BUILDING CODE OF AUSTRALIA COMPLIANCE ASSESSMENT REPORT

PROPOSED INDEPENDENT LIVING UNIT AND COMMUNAL BUILDING

181 ALLAMBIE HEIGHTS ROAD, ALLAMBIE HEIGHTS

REPORT NO. ► PROJECT 10141 - REV 2.1

Figure 1 – C2.6 Openings

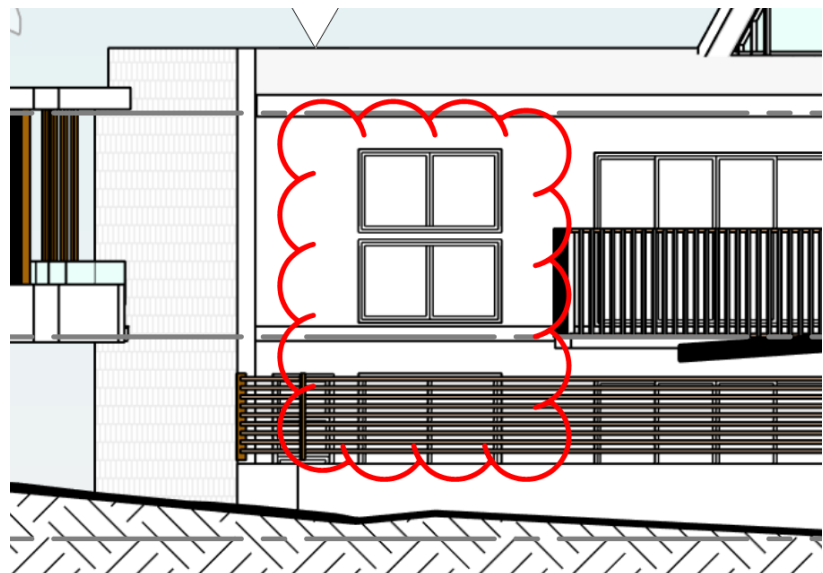
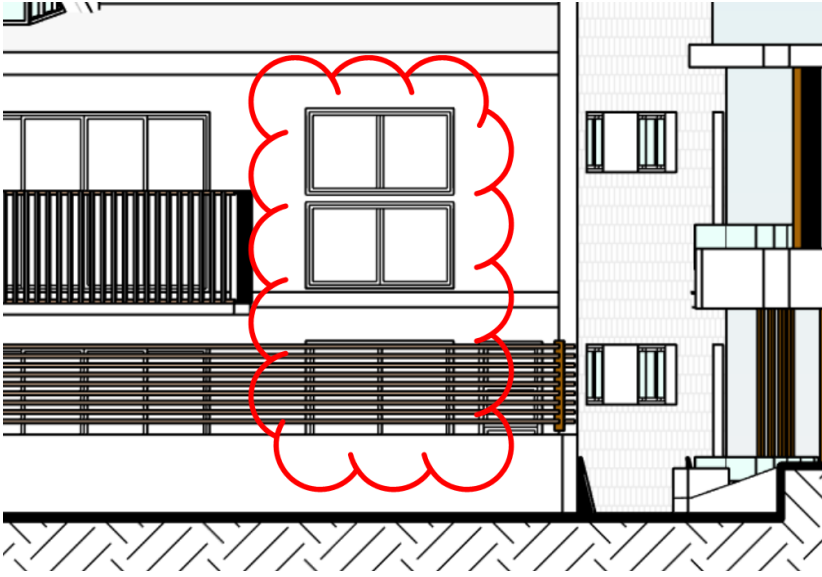
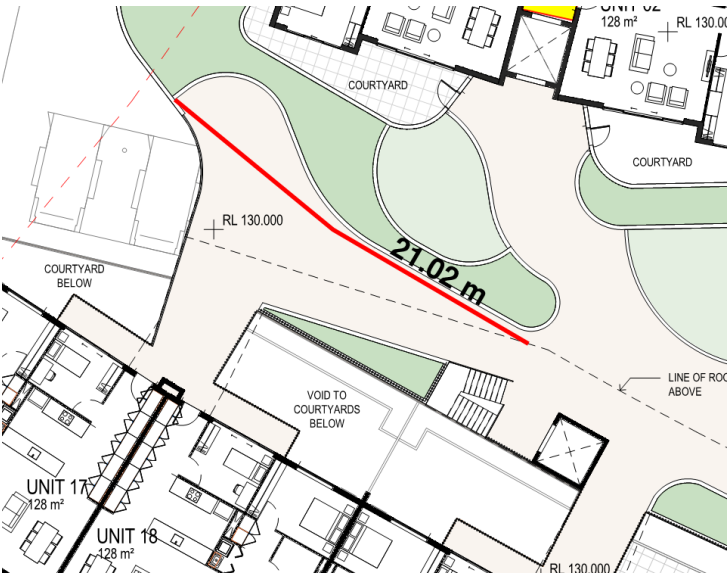
BCA Clause	Deemed-to-Satisfy Provision to be addressed
C2.6 Vertical Separation of openings in external walls	<p><u>Compliance commentary</u></p> <p>Buildings A & B</p> <ol style="list-style-type: none"> The 1100 mm horizontal construction proposed to separate openings in adjacent storeys must extend along the wall not less than 450 mm beyond the openings concerned. This was found to be non-compliant where balconies had been used as vertical separation in Buildings A & B, examples have been shown below to assist the designer. Alternatively, a performance solution would be required at CC stage. <p>EXAMPLE 1</p>  <p>EXAMPLE 2</p>

Figure C2.6(2) of the BCA Guide 2019 details compliant construction extending 450 mm past openings requiring protection:

Building B

- Northern elevation, vertical separation required to be provided between unit 16 and 24.

BCA Clause	Deemed-to-Satisfy Provision to be addressed
	<p>3. Northern elevation, vertical separation required to be provided between unit 09 and 17.</p>  <p>4. Northern elevation, unclear if vertical separation has been provided to openings located between the occupant walkways serving level 2. The openings in question have been identified below in Figure 1.</p>
<p>C2.8</p> <p>Separation of Classifications in the same storey</p>	<p>Compliance commentary</p> <ol style="list-style-type: none"> 1. The class 2 units and class 7a carpark on the lower ground floor must be separated with a fire wall achieving an FRL of not less than 120/120/120. Alternatively, discuss to see if a reduction in FRL's is possible under a performance solution. 2. The class 7b bin room and class 7a carpark must be separated with a fire wall achieving an FRL of not less than 240/240/240. Alternatively, discuss to see if a reduction in FRL's is possible under a performance solution.

Figure 4 – Travel distance via western stairway (ground)

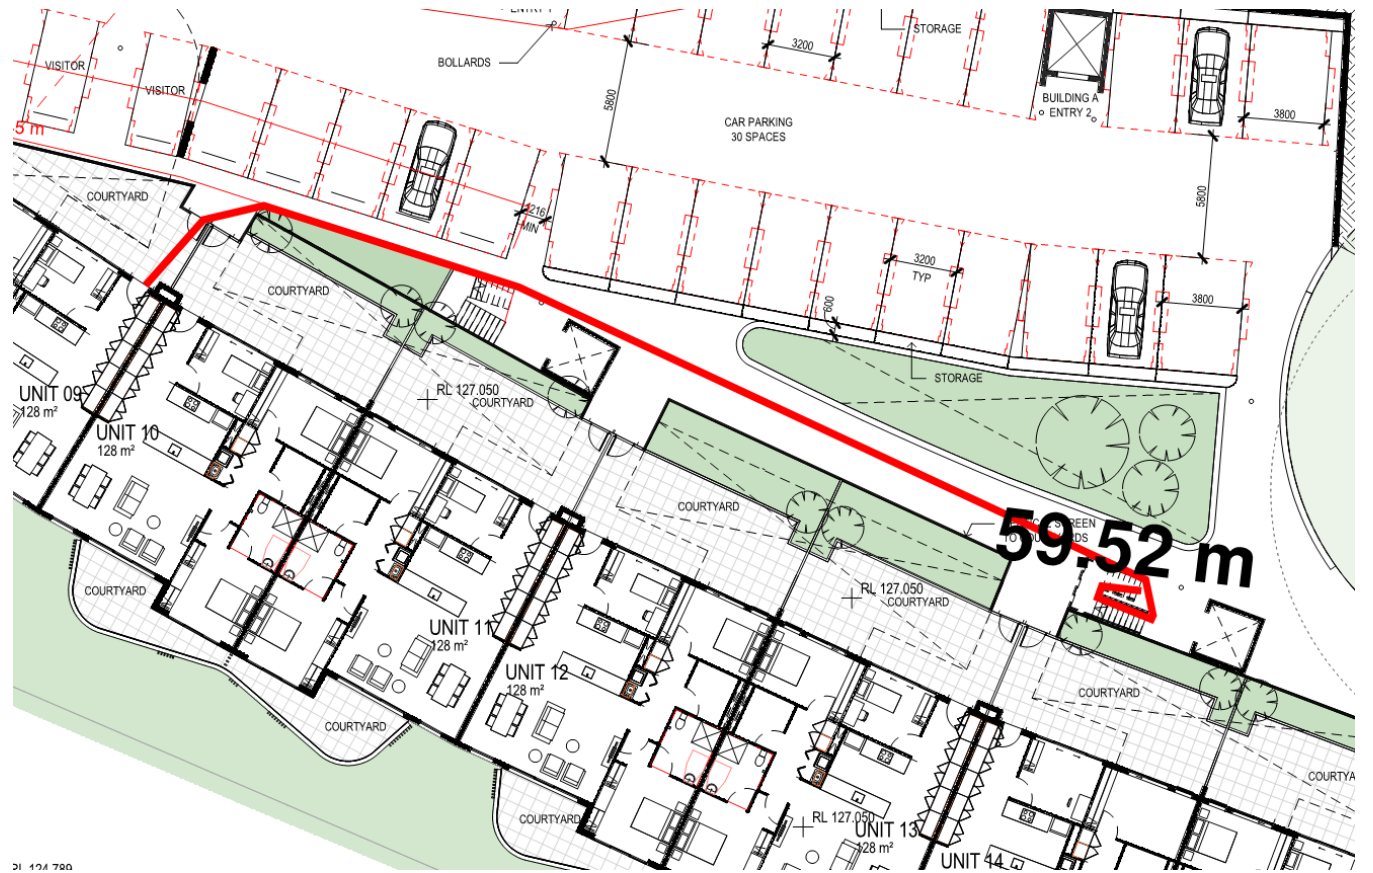
BCA Clause	Deemed-to-Satisfy Provision to be addressed
<p>D1.9</p> <p>Travel by non-fire-isolated stairs</p>	<p>Compliance commentary</p> <p>Building B</p> <ol style="list-style-type: none"> 1. The distance between the doorway of units 17, 18, 19, 20, 21, 22, 23 and 24 via the western non-fire-isolated stairway and the open space on lower ground floor exceed 60 m (worst case 114.1 m) and does not comply with clause D1.9(b)(ii). Where compliance with the DtS provisions is not achievable a fire engineered solution should be sought out. <p>Note (1): The western most central non-fire-isolated stairway is required for travel distances purposes and therefore must comply with this clause.</p> <ol style="list-style-type: none"> 2. The distance between the doorway of units 09, 10, 11, 12, 13, 14, 15 and 16 to the point of egress on ground floor (top of eastern non-fire-isolated ramp) via the eastern non-fire-isolated stairway, exceeds 60 m (worst case 127.6 m) and does not comply with clause D1.9(b)(ii). Where compliance with the DtS provisions is not achievable a fire engineered solution should be sought out. <p>Note (2): The eastern most central non-fire-isolated stairway is required for travel distances purposes and therefore must comply with this clause.</p> <p>Note (3): The point of egress via non-fire-isolated stairways and ramps has been taken to 6 m past the external wall of the building.</p> <ol style="list-style-type: none"> 3. The distance between the point of discharge of the eastern non-fire-isolated stair (on ground level) and the top of the eastern non-fire-isolated ramp exceeds 15 m (measured 18.8 m) and does not comply with clause D1.9(d)(i) as the discharge is to an external ramp, not a doorway. 4. The distance between the point of discharge of the western non-fire-isolated stair (on lower ground level) and the edge of roof line at western building end exceeds 15 m (measured 26.5 m) and does not comply with clause D1.9(d)(i), as the discharge is to an external opening and not a doorway.

Figure 1 – C2.6 Openings

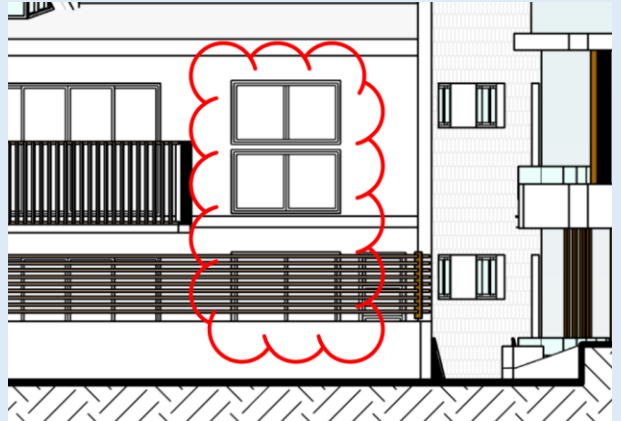
BCA DEEMED-TO-SATISFY PROVISION	COMPLIES	DOES NOT COMPLY	NA or Informational	Compliance Required	COMMENTS
					<p>(C) Is of non-combustible material having an FRL on not less 60/60/60; or</p> <p>(ii) A slab or other horizontal construction that –</p> <p>(A) Projects outwards from the external face of the wall not less than 1100mm; and</p> <p>(B) Extends along the wall not less than 450mm beyond the openings concerned; and</p> <p>(C) Is non-combustible and has an FRL of not less than 60/60/60.</p> <p>(b) The requirements of (a) do not apply to –</p> <p>(i) An open-deck carpark; or</p> <p>(ii) Openings in external walls where the floor separating the storeys does not require an FRL with respect to integrity and insulation.</p> <p>(c) For the purposes of C2.6, window or other opening means that part of the external wall of a building that does not have an FRL of 60/60/60 or greater.</p> <p>Compliance commentary</p> <p>1. The 1100 mm horizontal construction proposed to separate openings in adjacent storeys must extend along the wall not less than 450 mm beyond the openings concerned. This was found to be non-compliant where balconies had been used as vertical separation in Buildings A & B, examples have been shown below to assist the designer. Alternatively, a performance solution would be required at CC stage.</p> <p>EXAMPLE 1</p>

BCA DEEMED-TO-SATISFY PROVISION	COMPLIES	DOES NOT COMPLY	NA or Informational	Compliance Required	COMMENTS
					<p>EXAMPLE 2</p>  <p>Figure C2.6(2) of the BCA Guide 2019 details compliant construction extending 450 mm past openings requiring protection:</p>  <p>Building B</p> <p>2. Northern elevation, vertical separation is required to be provided between unit 16 and 24.</p>

BCA DEEMED-TO-SATISFY PROVISION	COMPLIES	DOES NOT COMPLY	NA or Informational	Compliance Required	COMMENTS
					<p>3. Northern elevation, vertical separation is required to be provided between unit 09 and 17.</p>  <p>4. Northern elevation, unclear if vertical separation has been provided to openings located between the occupant walkways serving level 2. The openings in question have been identified below in Figure 1.</p> <p>Details demonstrating compliance with this clause must be incorporated into the construction certificate plans / specification</p>

Figure 2 – Lower Ground Travel Distance

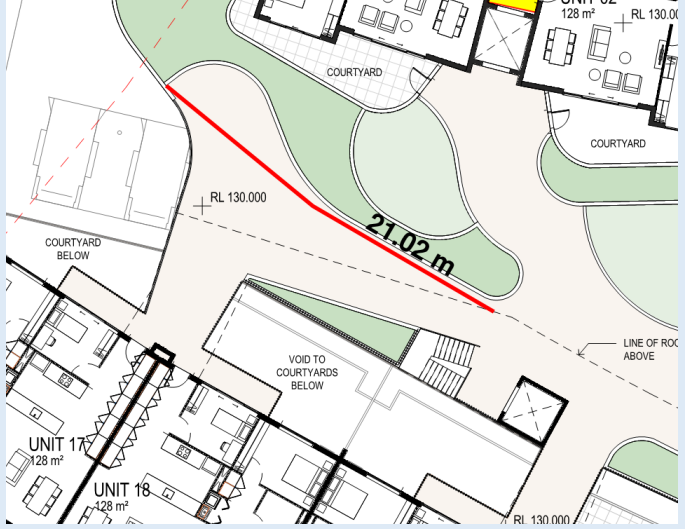
BCA DEEMED-TO-SATISFY PROVISION	COMPLIES	DOES NOT COMPLY	NA or Informational	Compliance Required	COMMENTS
D1.4 Exit Travel Distances		X			<p>(a) Class 2 buildings—</p> <p>(i) The entrance doorway of any sole-occupancy unit must be not more than—</p> <p>(A) 6 m from an exit or from a point from which travel in different directions to 2 exits is available; or</p> <p>(B) 20 m from a single exit serving the storey at the level of egress to a road or open space; and</p> <p>(ii) no point on the floor of a room which is not in a sole-occupancy unit must be more than 20 m from an exit or from a point at which travel in different directions to 2 exits is available.</p> <p>(b) Class 7 or 9 buildings —</p> <p>(i) no point on a floor must be more than 20 m from an exit, or a point from which travel in different directions to 2 exits is available, in which case the maximum distance to one of those exits must not exceed 40 m;</p> <p><u>Compliance commentary</u></p> <p>Building B</p> <p>1. Lower ground floor; the travel distance from Units 11, 12, 13, 14, 15 and 16 exceed 6m to a point of choice where egress is available to two exits (worst case 20 m). The architectural plans are required to demonstrate compliance or alternatively discuss with fire safety engineer to determine if a performance solution can be developed.</p> <p>Note (1): Units 11, 12, 13 and 14 travel distance to a point of choice vary between 7.5 m and 9 m.</p> <p>Note (2): Units 15 and 16 have a travel distance to a point of choice of 19 m and 20 m respectively.</p> <p>Note (3): the ramp no longer serves the lower ground floor of building B, as such, the point of choice has been taken between the two central stairways.</p> <p>2. Ground floor; the travel distance from Units 17, 18, 19, 20, 21, 22, 23 and 24 exceed 6m to a point of choice where egress is available to two exits (worst case 19.6 m). The architectural plans are required to demonstrate compliance or alternatively discuss with fire safety engineer to determine if a performance solution can be developed.</p> <p>Note (4): Units 19, 20, 21, 22, 23 and 24 travel distance to a point of choice vary between 8.5 m and 9 m.</p> <p>Note (5): Units 17 and 18 have a travel distance to a point of choice of 19 m and 19.6 m respectively.</p>

BCA DEEMED-TO-SATISFY PROVISION	COMPLIES	DOES NOT COMPLY	NA or Informational	Compliance Required	COMMENTS
					<p>3. Ground floor; the travel distance from the western end of the ground floor elevated walkway exceeds 20 m to a point of choice (measured 21 m). The architectural plans are required to demonstrate compliance or alternatively discuss with fire safety engineer to determine if a performance solution can be developed.</p>  <p><i>Details demonstrating compliance with this clause must be incorporated into the construction certificate plans / specification</i></p>

Figure 6 – Travel distance via eastern stairway (lower ground)

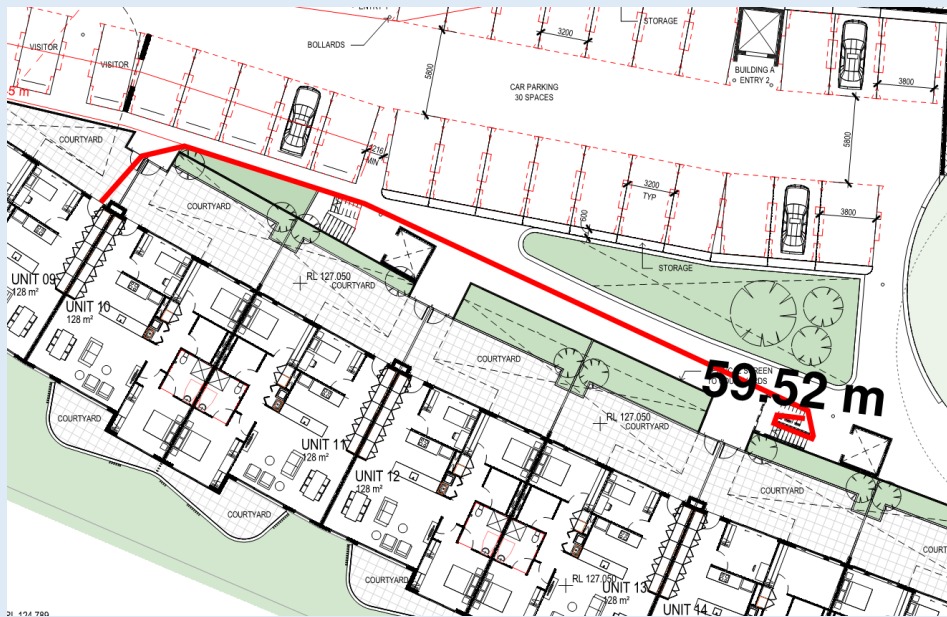
BCA DEEMED-TO-SATISFY PROVISION	COMPLIES	DOES NOT COMPLY	NA or Informational	Compliance Required	COMMENTS
					<p>passageway leading to a road or open space; or</p> <p>(ii) 30 m from one of 2 such doorways or passageways if travel to each of them from the non-fire-isolated stairway or non-fire-isolated ramp is in opposite or approximately opposite directions.</p> <p>(d) In a Class 5 to 8 or 9b building, a required non-fire-isolated stairway or non-fire-isolated ramp must discharge at a point not more than—</p> <p>(i) 20 m from a doorway providing egress to a road or open space or from a fire isolated passageway leading to a road or open space; or</p> <p>(ii) 40 m from one of 2 such doorways or passageways if travel to each of them from the non-fire-isolated stairway or non-fire-isolated ramp is in opposite or approximately opposite directions.</p> <p><u>Compliance commentary</u></p> <p>Building B</p> <p>1. The distance between the doorway of units 17, 18, 19, 20, 21, 22, 23 and 24 via the western non-fire-isolated stairway and the open space on lower ground floor exceed 60 m (worst case 114.1 m) and does not comply with clause D1.9(b)(ii). Where compliance with the DtS provisions is not achievable a fire engineered solution should be sought out.</p> <p>Note (1): The western most central non-fire-isolated stairway is required for travel distances purposes and therefore must comply with this clause.</p> <p>2. The distance between the doorway of units 09, 10, 11, 12, 13, 14, 15 and 16 to the point of egress on ground floor (top of eastern non-fire-isolated ramp) via the eastern non-fire-isolated stairway, exceeds 60 m (worst case 127.6 m) and does not comply with clause D1.9(b)(ii). Where compliance with the DtS provisions is not achievable a fire engineered solution should be sought out.</p> <p>Note (2): The eastern most central non-fire-isolated stairway is required for travel distances purposes and therefore must comply with this clause.</p> <p>Note (3): The point of egress via non-fire-isolated stairways and ramps has been taken to 6 m past the external wall of the building.</p> <p>3. The distance between the point of discharge of the eastern non-fire-isolated stair (on ground level) and the top of the eastern non-fire-isolated</p>

BCA DEEMED-TO-SATISFY PROVISION	COMPLIES	DOES NOT COMPLY	Informational	NA or	Compliance Required	COMMENTS
						<p>ramp exceeds 15 m (measured 18.8 m) and does not comply with clause D1.9(d)(i) as the discharge is to an external ramp, not a doorway.</p> <p>4. The distance between the point of discharge of the western non-fire-isolated stair (on lower ground level) and the edge of roof line at western building end exceeds 15 m (measured 26.5 m) and does not comply with clause D1.9(d)(i), as the discharge is to an external opening and not a doorway.</p> <p>Details demonstrating compliance with this clause must be incorporated into the construction certificate plans / specification</p>

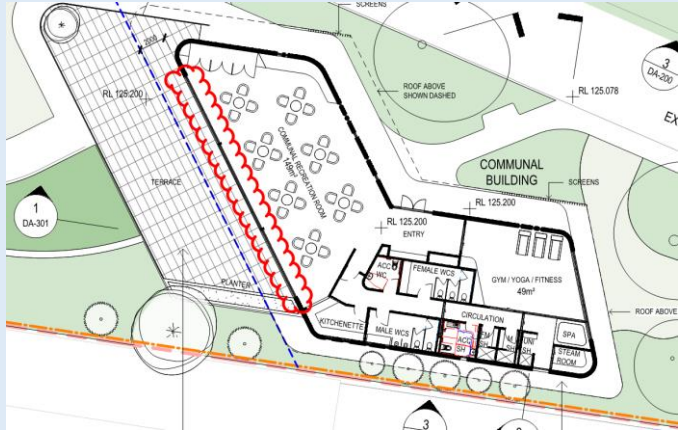
BCA DEEMED-TO-SATISFY PROVISION	COMPLIES	DOES NOT COMPLY	NA or Informational	Compliance Required	COMMENTS
Width of Stairs					
D2.10 Pedestrian Ramps				X	<p>(a) A ramp serving as a required exit must –</p> <p>(i) Where the ramp is also serving as an accessible ramp under Part D3, be in accordance with AS1428.1; or</p> <p>(ii) In any other case, have a gradient not steeper than 1:8.</p> <p>(b) The floor surface of a ramp must have a slip-resistance classification not less than that listed in Table D2.14 when tested in accordance with AS4586.</p> <p><i>Details demonstrating compliance with this clause must be incorporated into the construction certificate plans / specification</i></p>
D2.11 Fire-Isolated Passageways			X		Not applicable.
D2.12 Roof as Open Space		X			<p>If an exit discharges to the roof of a building the roof must –</p> <p>(a) Have an FRL not less than 120/120/120; and</p> <p>(b) Not have any roof lights or other openings with 3m of the path of travel of persons using the exit to reach a road of open space.</p> <p><u>Compliance commentary</u></p> <p>1. The path of travel from the discharge point of the eastern non-fire-isolated stairway on ground floor necessitates passing within 3 m of two (2) void openings and does not comply with this clause. The void openings have been shown highlighted below for reference:</p>

BCA DEEMED-TO-SATISFY PROVISION	COMPLIES	DOES NOT COMPLY	NA or Informational	Compliance Required	COMMENTS
					<p>2. The elevated walkway central to Building A/B must achieve and FRL of not less than 120/120/120, in accordance with this clause.</p> <p>Details demonstrating compliance with this clause must be incorporated into the construction certificate plans / specification</p>
D2.13 Goings & Risers				X	<p>Stairways to achieve compliance with this clause relevant to going and riser dimensions.</p> <p>Stairways to achieve constant risers & goings except where minor variations are permitted over flight as detailed in the clause.</p> <p>Treads must have a surface with a slip-resistant classification not less than that listed in Table D2.14 when tested in accordance with AS4586.</p> <p>Details demonstrating compliance with this clause must be incorporated into the construction certificate plans / specification</p>
